From: Ian Pinfold
Sent: 14 March 2024 09:35
To: Matt Jedruch; Lesley Keal
Cc: Paul Scragg; Tony Cunnington
Subject: FW: Hinckley West Football Pitches
Attachments: DE_155L_Cover Letter_2024 02 19_SP.pdf; DE_155_SP_001-Landscape Masterplan.pdf; DE_155_SP_003-Landscape Sections.pdf

Hi both good morning, I note the changes detailed within the covering letter and the revised Landscape Masterplan (Ref DE_155_SP_002, Rev. B) dated the 25/01/24 with regards to reserved matters and discharge of conditions, The delivery of the sport pitches (Planning App Refs 23/01139/REMM & 23/01169/DISCON).

LAND WEST OF NORMANDY WAY, HINCKLEY: RESERVED MATTERS AND DISCHARGE OF CONDITIONS APPLICATIONS IN RELATION TO THE DELIVERY OF SPORTS PITCHES (PLANNING APPLICATION REFS: 23/O1139/REMM AND 23/O1169/DISCON)

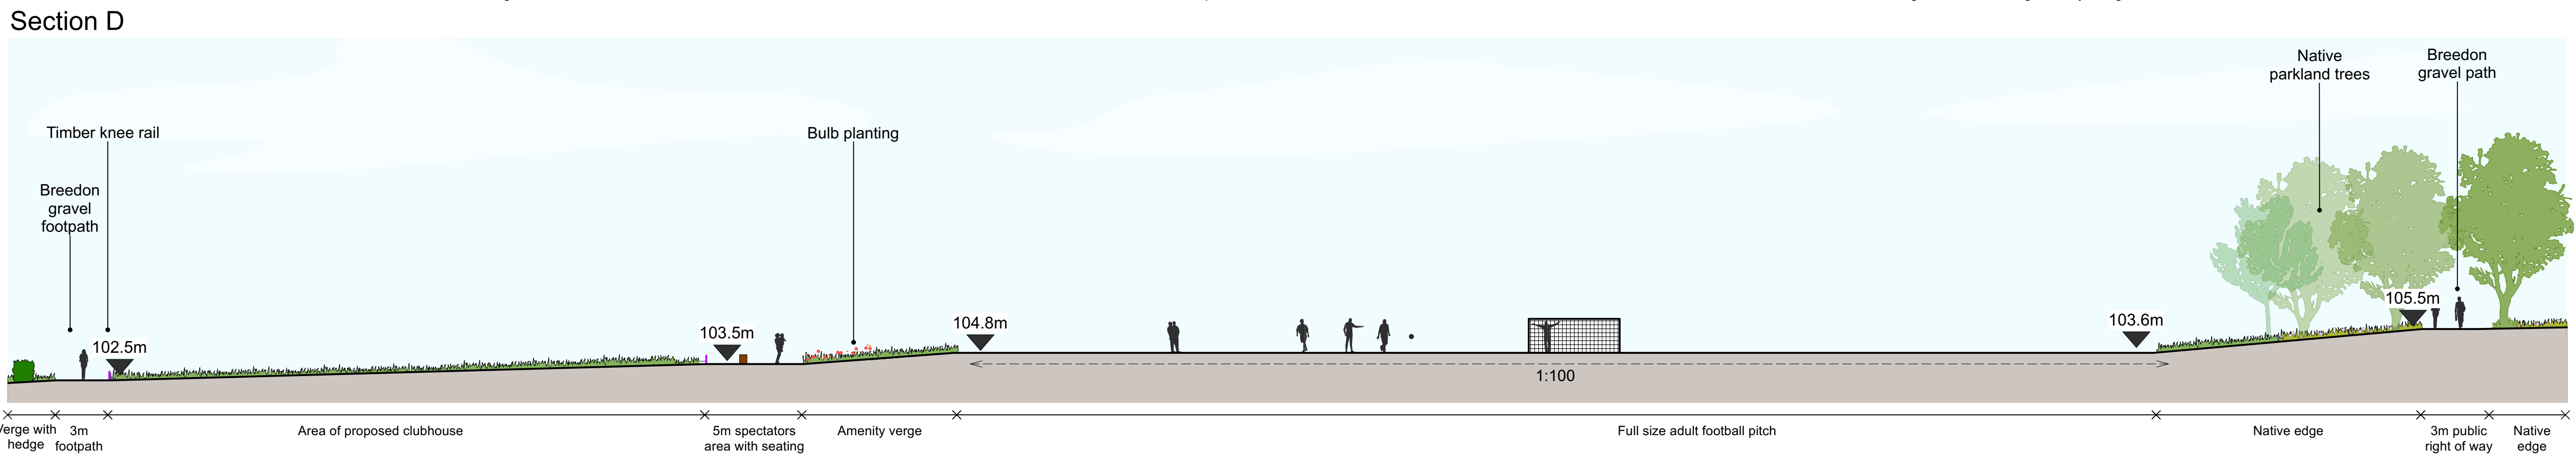
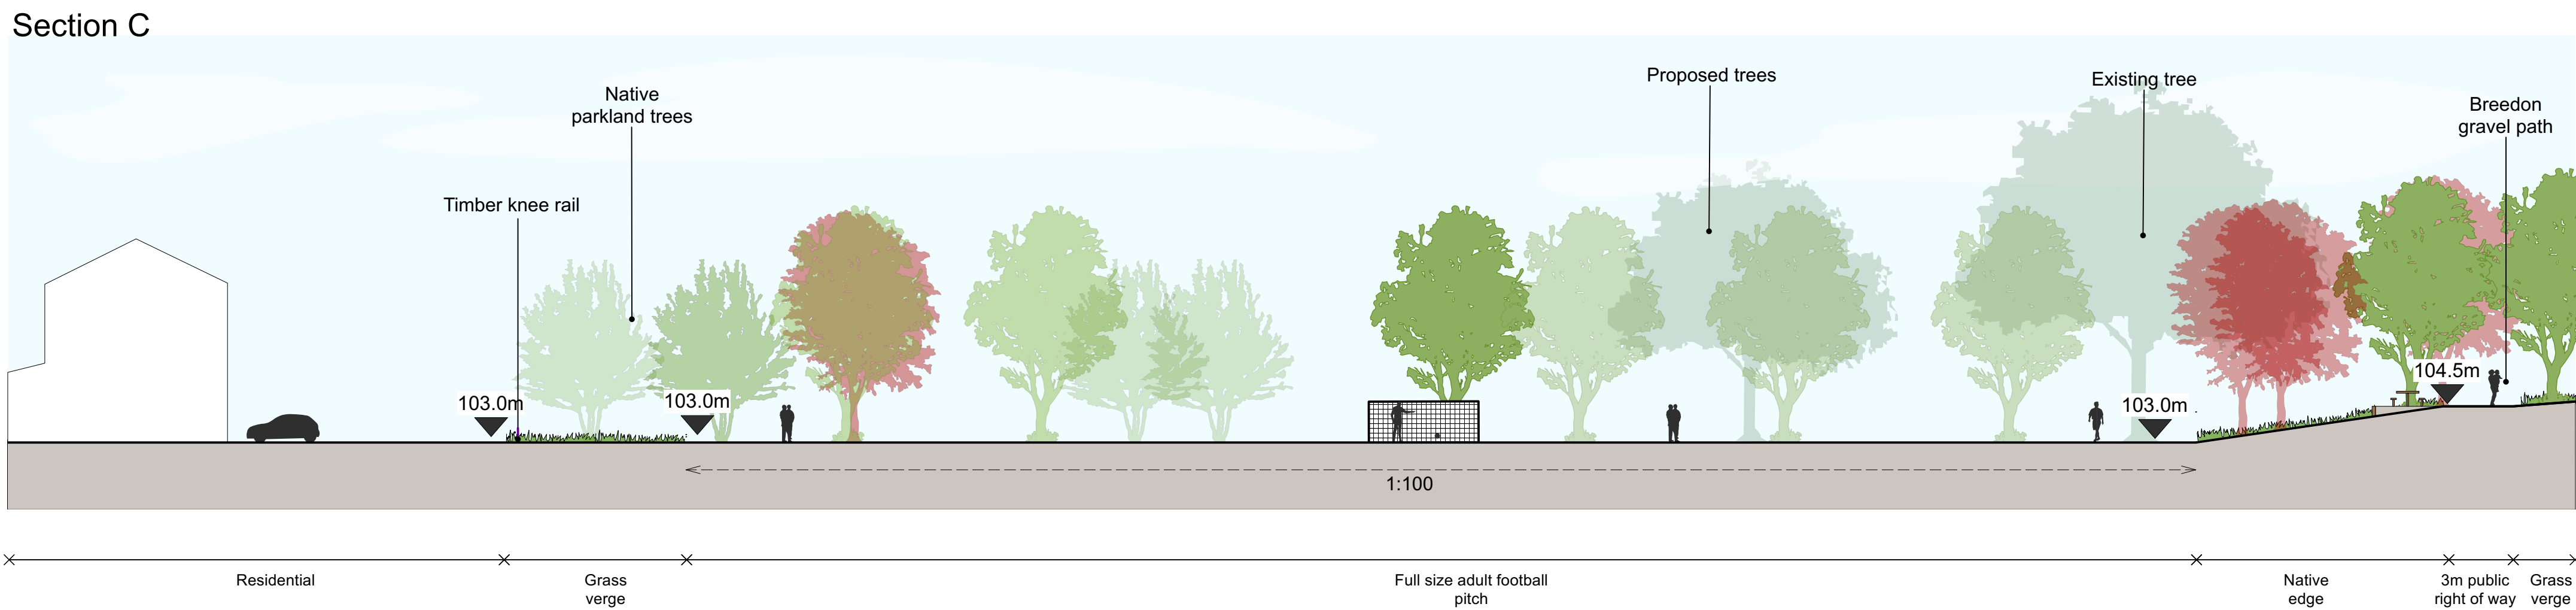
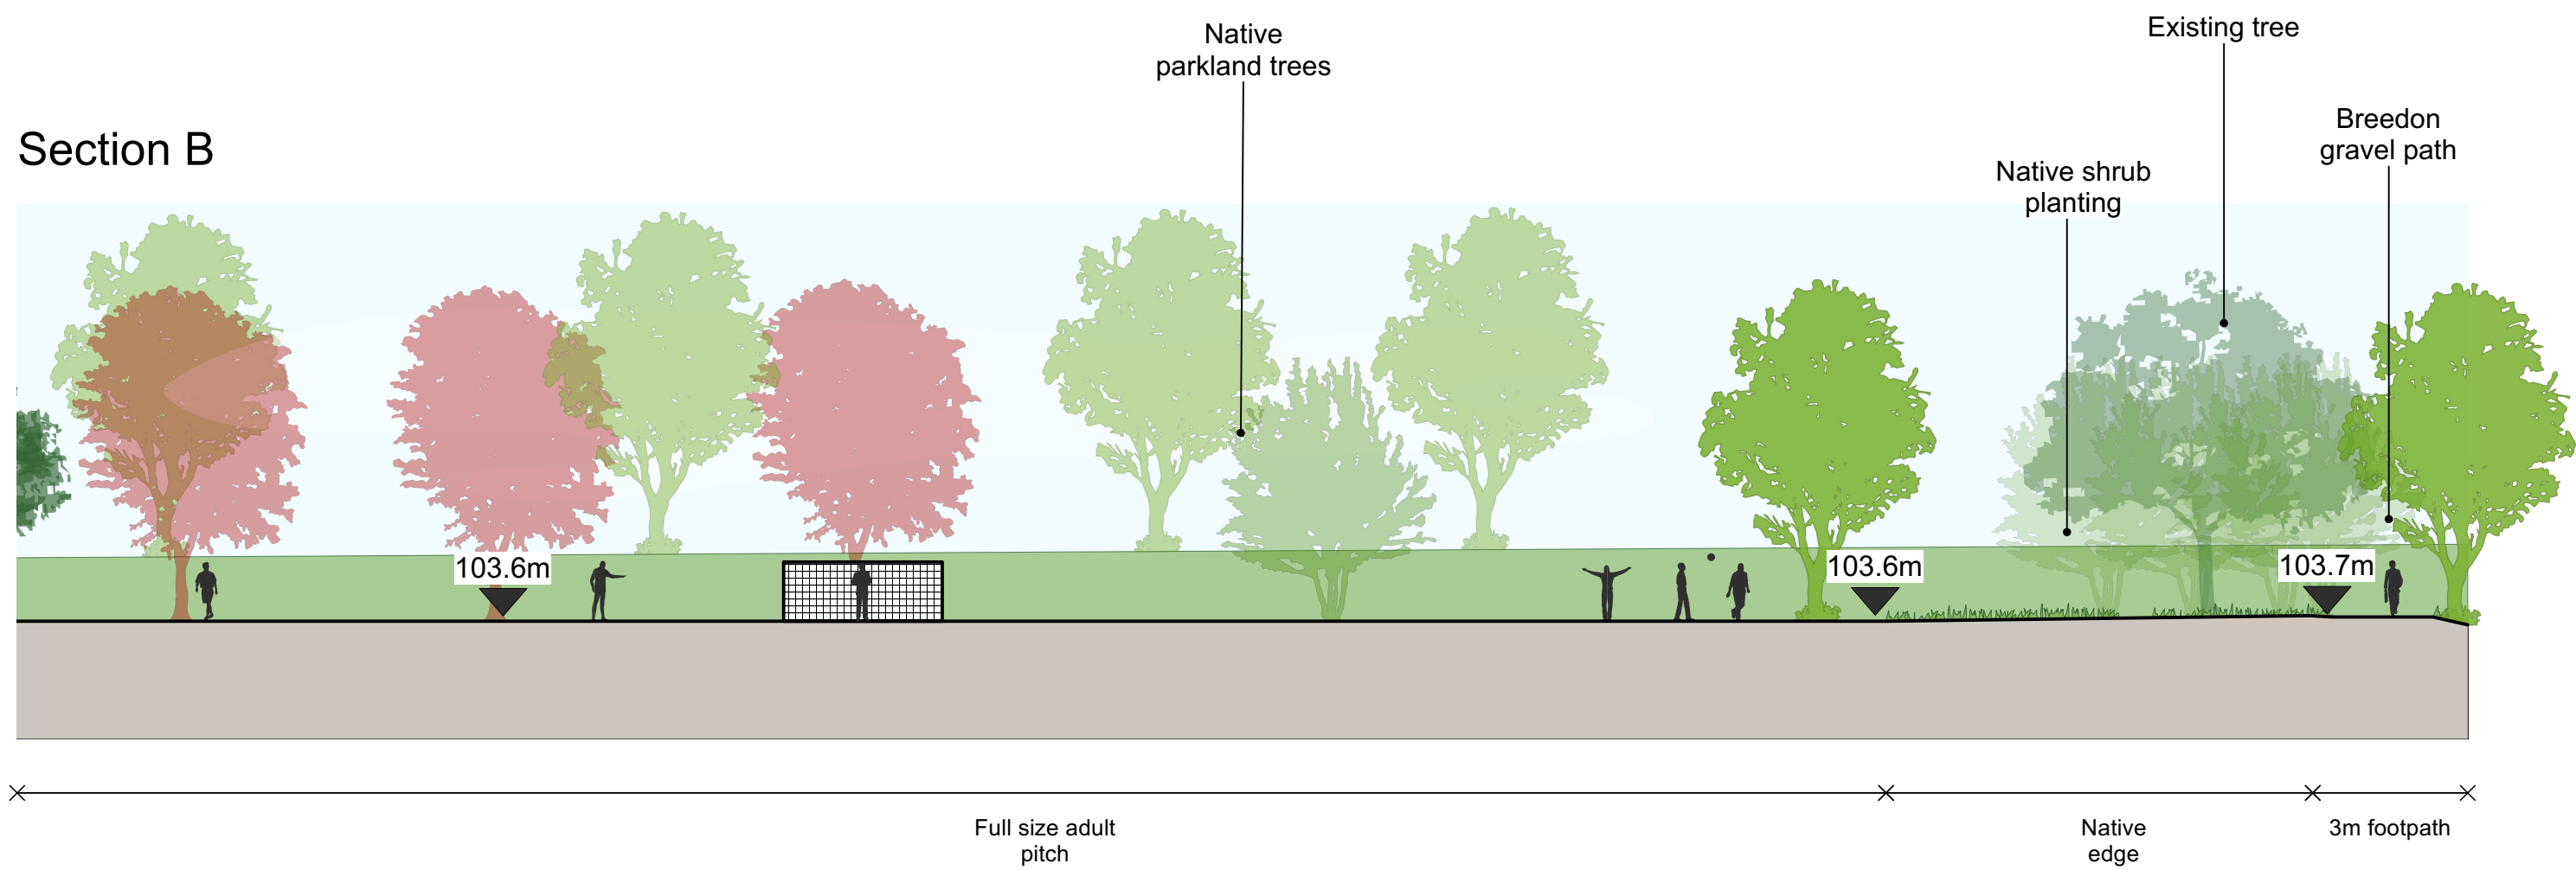
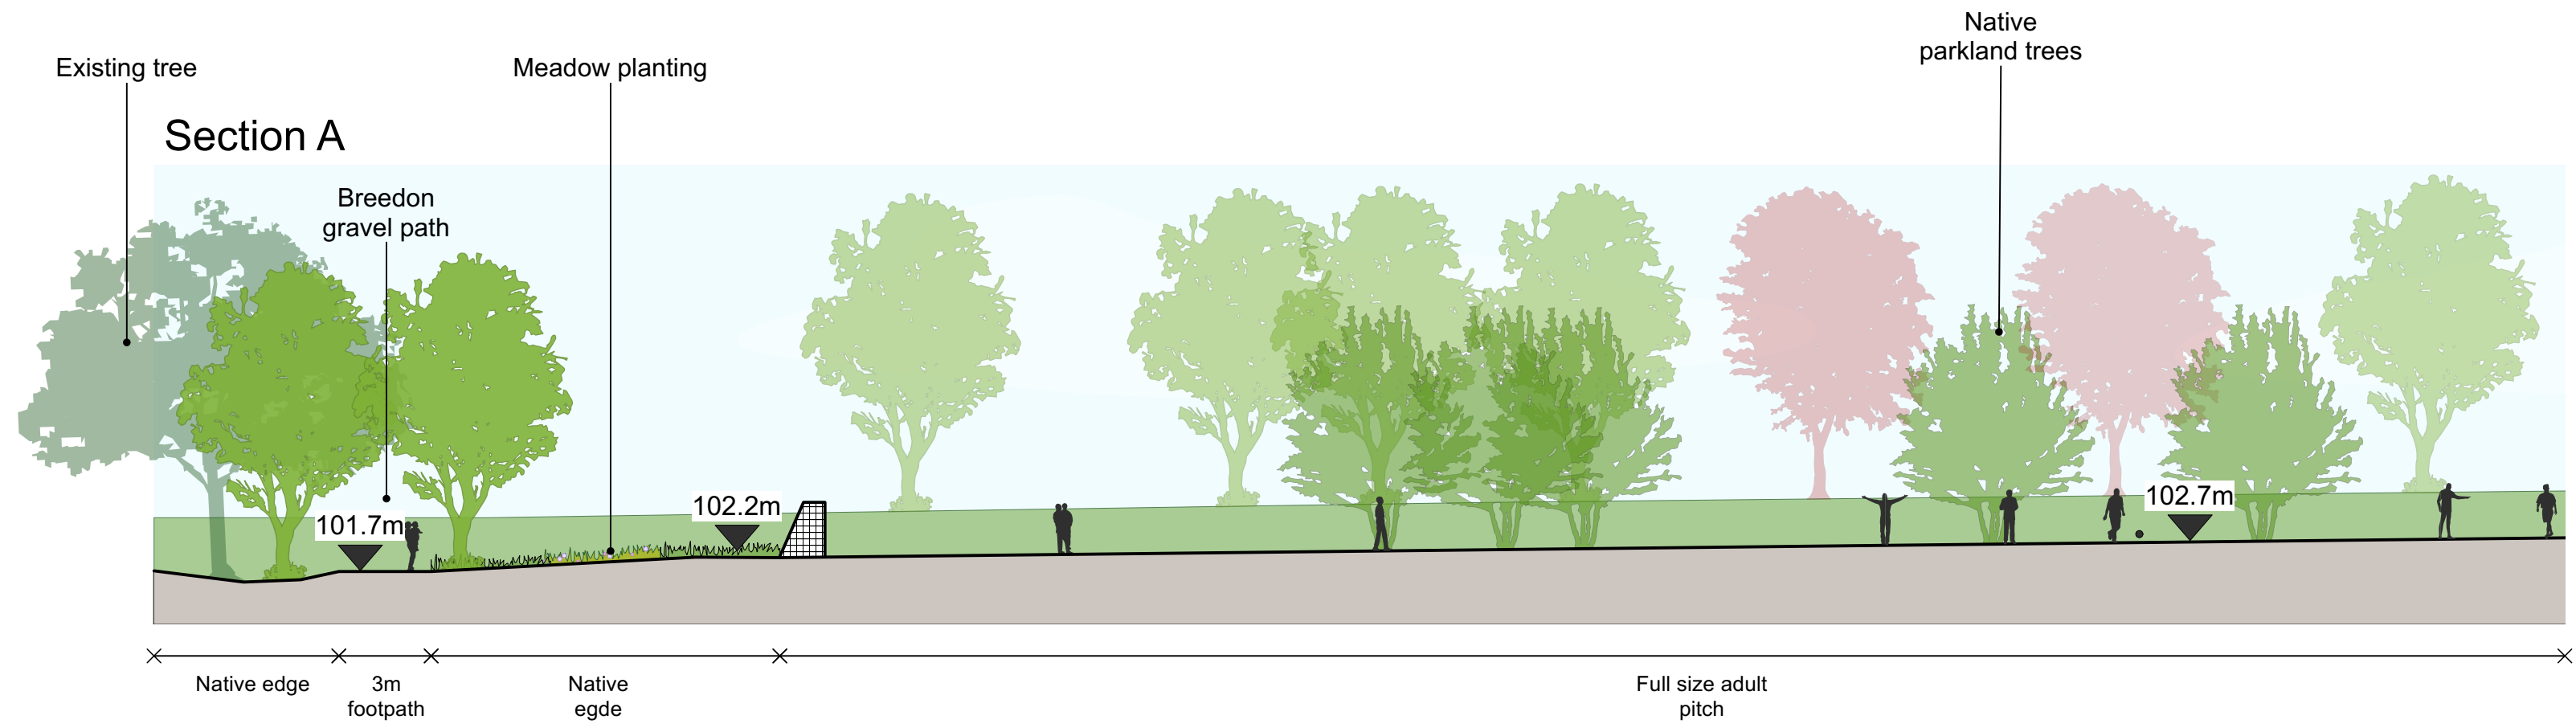
The new levels detailed to the pitches are now more consistent in terms of facilitating surface water drainage. I am pleased to see to the eastern playing pitch, a land drain is to be installed to the south that will hopefully intercept any surface run-off. It would be useful, if further information could be supplied regarding this drain, a drawing showing construction details, also, the outfall details, whether this will be discharged into the developments suds system or into adopted system (STW).

In terms of the two pitches to the west there is no proposal to install a land drain to intercept surface water run-off at this stage. I noted, they detail “*they are comfortable that the pitches will drain sufficiently , although there would be a potential to consider an additional drain to the south of the western pitch if required*”.

My preference would be to see this drain to be a part of the reserved matter and in addition to this, an extra land drain at the end of the western pitch running north to south joining into the southern drain and then to the ditch system. This would greatly alleviate the potential flooding the adjacent areas to the south and west of the pitches. It again would be useful to establish the ownership of the ditch and whether the relevant permissions have been sort to discharge into this system.

It would also be beneficial to see the levels to the landscape surrounding the pitches in order to fully evaluate the overall impact of surface water run-off to the adjacent areas.

They detail the pitches will be topsoiled; it would be helpful to have further information in relationship to this work eg. the type of soil to be utilised (soil analysis details) the depth and a specification on how this work will be undertaken.

We note that the officer has raised concerns as to a perceived crossfall to the pitches. The detailed design proposals have been reviewed by BHL's engineering team and Define's landscape team to ensure that the plans accurately convey the proposed levels for the application site, which ties in with the levels strategy for the wider Normandy Fields development. To confirm, there will be no crossfall within the area, and the pitches will fall at a gradient of 1:100. That has been reflected in the updated Landscape Masterplan, as well as the Landscape Sections.

The proposed site levels also inform the pitch drainage strategy, with the 1:100 gradient allowing for surface water run-off rather than requiring a permeable drainage solution. The eastern playing pitch will fall gently from north to south, and will drain to a land drain at the southern boundary of the application site which will intercept surface water run-off. The two pitches to the west of that (i.e. those oriented broadly north-west to south-east) will fall gently towards a ditch at the west of the application site.

In light of that drainage strategy, it is proposed that the pitches will be topsoiled. On that basis, BHL are comfortable that the pitches will drain sufficiently as proposed, although there is potential to consider an additional drain to the south of the western pitch if that is required.
